7-9, 14-18 & 19-21 Chalmers Crescent, Mascot

For City of Botany Bay Council

Peer Review: Traffic & Parking Assessment

8 April 2016

1 GROUND FLOOR PLAN - CARPARK
SCALE 1:1000 @ A3

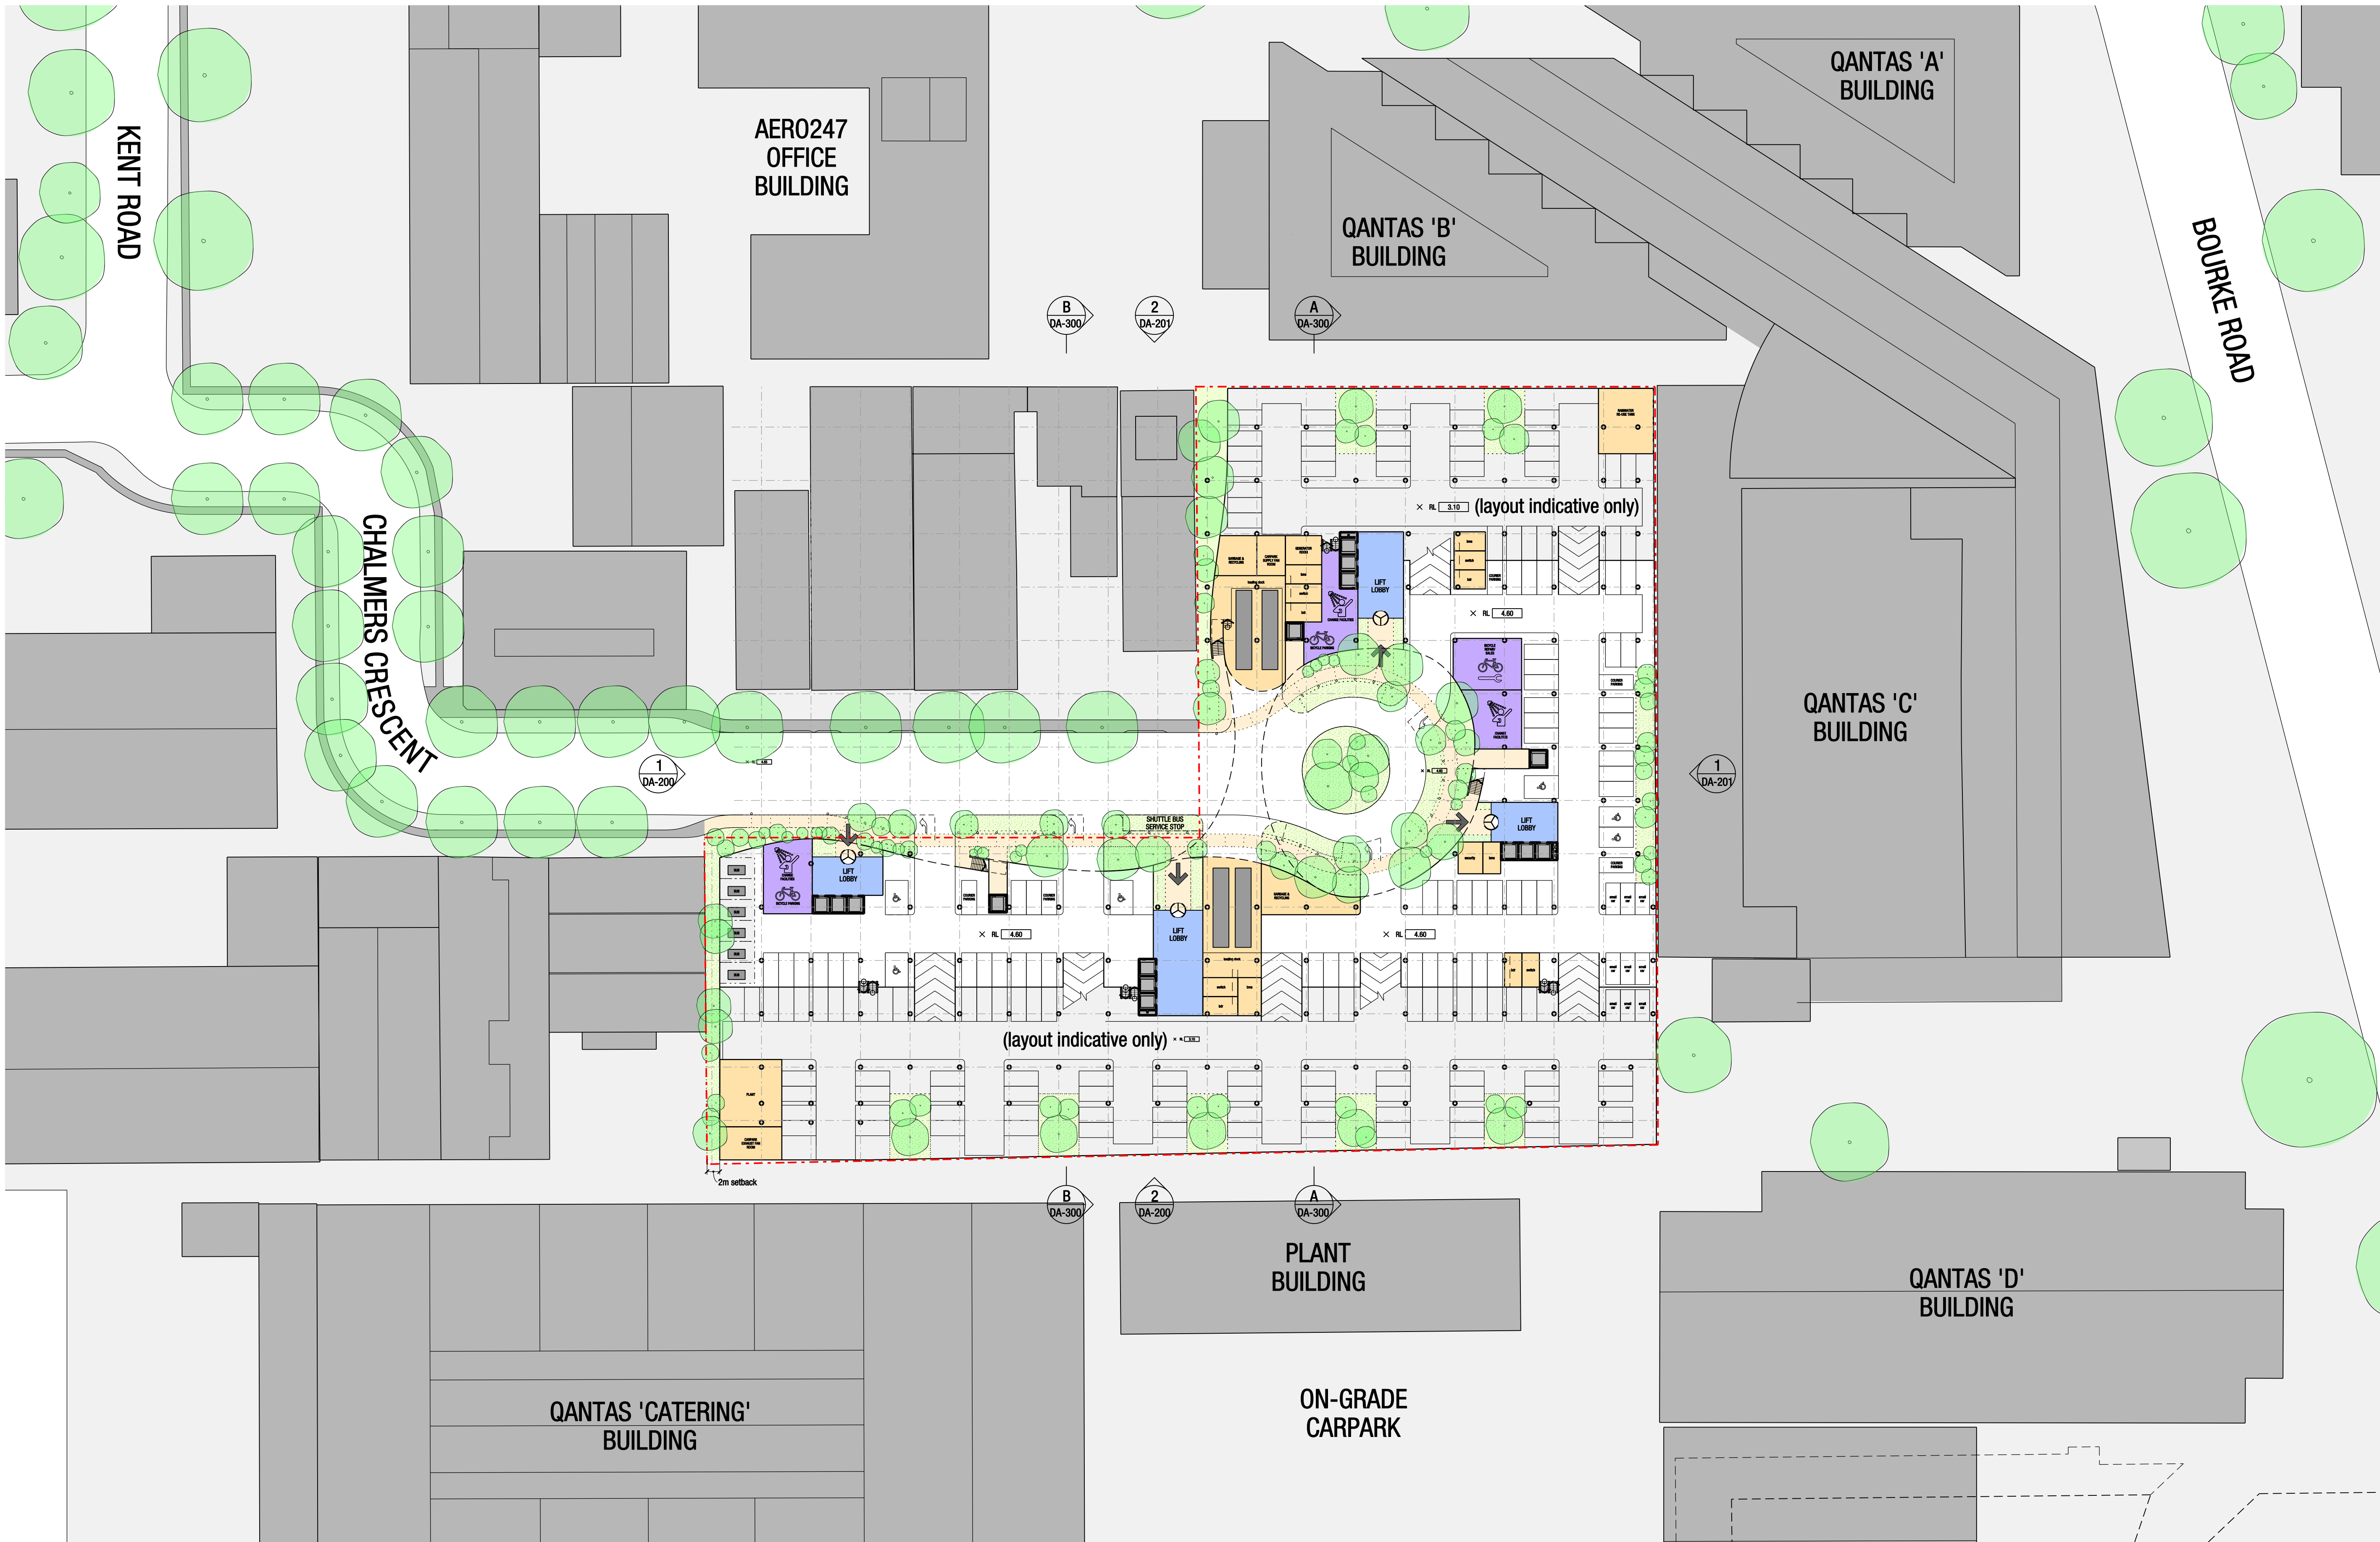
No.	ITEM	STATUS	COMMENTS
2.4.1	Car Park Arrangement	AC	<p>Being still in the master planning stage, no formal assessment of the proposed car park has been undertaken in accordance with AS2890.1:2004. It is emphasised that, notwithstanding compliance, the car park design relies heavily on numerous no-through arrangements with blind aisles, some of which have no turning bays provided. As a result of the layout, circulation and traffic flow can be restricted, and wayfinding will be poor as a result. From experience, with a car park of this scale, such deficiencies could lead to considerable issues in management of the car park, including internal congestion, damage to property, and if severe enough, a loss in the usage of the car park.</p> <p>Recommendations:</p> <p>A complete review of the car park and access arrangements will be required for the assessment of any subsequent DA's. In addition to consideration of the requirements of AS2890.1:2004, AS2890.2:200, AS2890.3:2015 & AS2890.6:2009, it is strongly recommended to reconsider car park circulation, and the implementation of a parking guidance system (PGS) or allocation of parking whilst there is an opportunity to do so.</p>

2.4.2	Site Service Arrangement	NC	<p>Revision L Architectural drawings indicate that the site boundary encompasses the Chalmers Crescent cul-de-sac, and hence, all reverse manoeuvres associated with loading bay access are shown to occur within the property boundary.</p> <p>PTC is not aware of any agreed relocation of the property boundary, resulting in the ownership of a portion of the public road. Regardless, the location of the property boundary does not alleviate safety concerns resulting from the reverse movements of heavy vehicles into the service bays. These concerns being as follows;</p> <ul style="list-style-type: none"> • The movements will occur across the primary pedestrian thoroughfares. Some movements are required to cross both footpaths; • The movements simultaneously must either drive or reverse across the road centreline, and obstruct the entry/exit to the proposed roundabout. Moreover, there are potential sight distance issues resulting from the proposed central-island landscaping. • It is considered that the large scale of the site will lead to difficulties in avoiding conflicts between the scheduled activities of deliveries, and the comparatively sporadic activities of staff. <p>Recommendations:</p> <ul style="list-style-type: none"> • Council to confirm location of property boundary; • Recommended to design service bays to allow for forward ingress and egress for the design vehicle.
